Register Reference: SDZ22A/0017 **Date:** 03-Jan-2023
Development: Construction of 157 dwellings within the Clonburris South-West Development Area of the Clonburris Strategic Development Zone (SDZ) Planning Scheme 2019 consisting of, 81 houses comprising of 4 two bedroom houses, 65 three bedroom houses and 12 four bedroom houses (all two storey with associated private open space and car parking; 76 apartment units consisting of 26 one bedroom and 50 two bedroom units within Block 1 (4 storeys); Vehicular access will be provided from the permitted street under SDZ21A/0022 and the permitted Clonburris Southern Link Street (SDZ20A/0021) and R113 (Fonthill Road) to the east; All ancillary site development works including footpaths, landscaping boundary treatments, public and private open space areas, car parking (170 spaces) and bicycle parking (170 spaces), single storey ESB sub-stations, bin and bicycle stores and all ancillary site development/construction works all on wider lands bounded generally by the Dublin-Cork railway line to the north, undeveloped lands and Grand Canal to the south and undeveloped lands and the Fonthill Road (R113) to the east, in accordance with the Clonbur

Figure 2.2.1 | Full Street Hierarchy

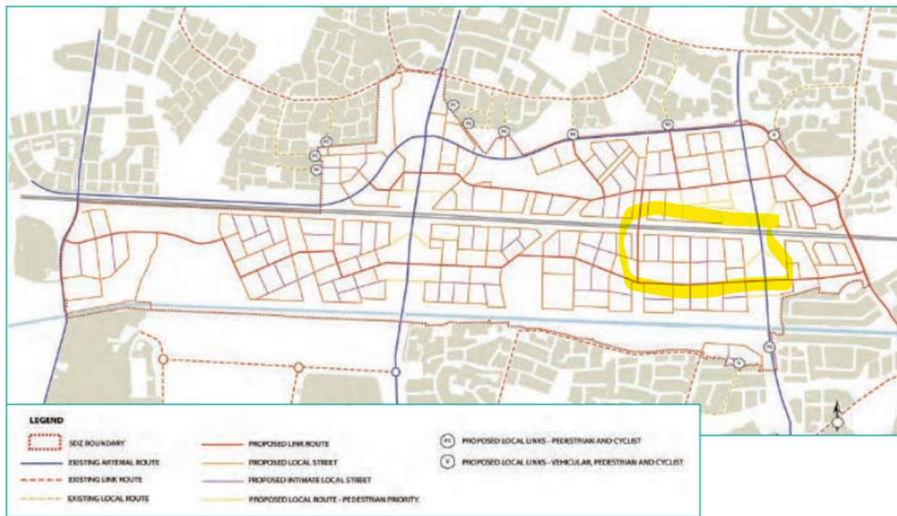
The roads hierarchy layout conforms in the main to the SDZ framework plan with a notable exception being the link street 18 (marked with an X below) is proposed as a 'local street' and not an 'intimate street' as per the SDZ layout.

Applicant is required to provide a justification for this departure from the Clonburris planning scheme framework. If there is no justification for the change, the applicant must submit a revised layout that reflects the Clonburris planning scheme framework.

1. Re road hierarchy/Street 18: Applicant is required to provide a justification for this departure from the Clonburris planning scheme framework. If there is no justification for the change, the applicant must submit a revised layout that accurately reflects the Clonburris planning scheme framework.

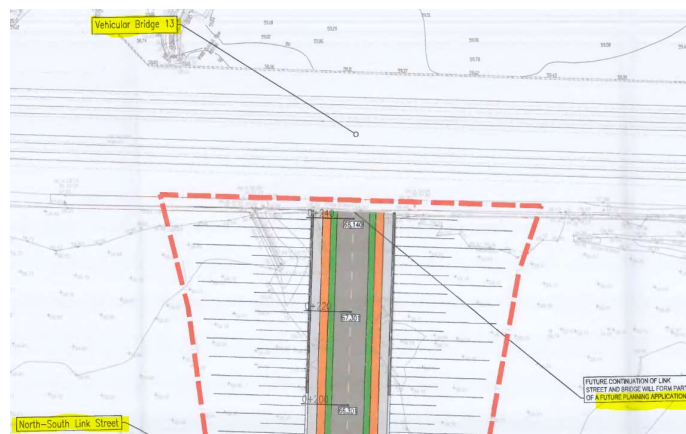
The granted “North-South Link Street” (SDZ20A/0021) makes provision for an **approach** to a vehicular bridge spanning the adjacent rail line. The green corridor, including cycletrack and footpath, on the southern rail boundary must continue through the subject site and links to cycle and pedestrian underpass must be provided and consistent with the existing and future permission (see diagram below). Applicant will be required to engage with all relevant bodies (TII, NTA, SDZ20A/0021 applicant, etc) and to submit plan, elevation & cross-section drawings of proposed vehicular bridge including cycle and pedestrian underpass detail, and associated public lighting, and to provide links from the subject site accordingly.

Reason: To ensure continuity of green corridor and safe passage for all users.

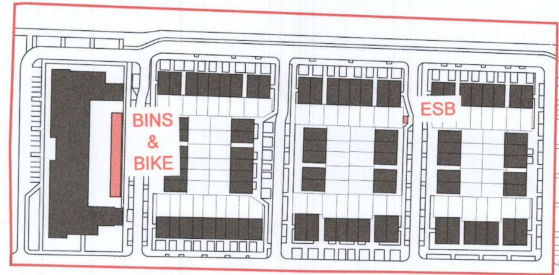
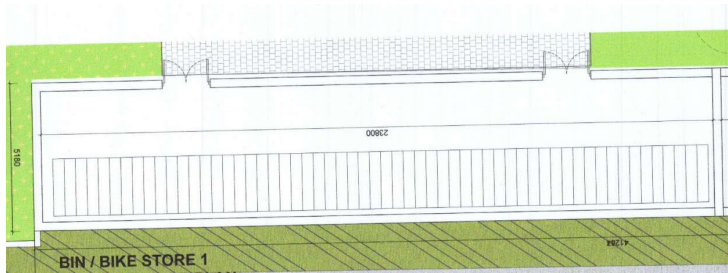
A total of 170no. car parking spaces (50no. apartment, 60no. on street & 60no. on curtilage) are proposed.

The maximum number of carpark spaces allowed for this development under the CDP 2022-28/Clonburris SDZ planning scheme would be 169.5no. The applicant has proposed 170no. spaces which SDCC Roads find to be satisfactory.
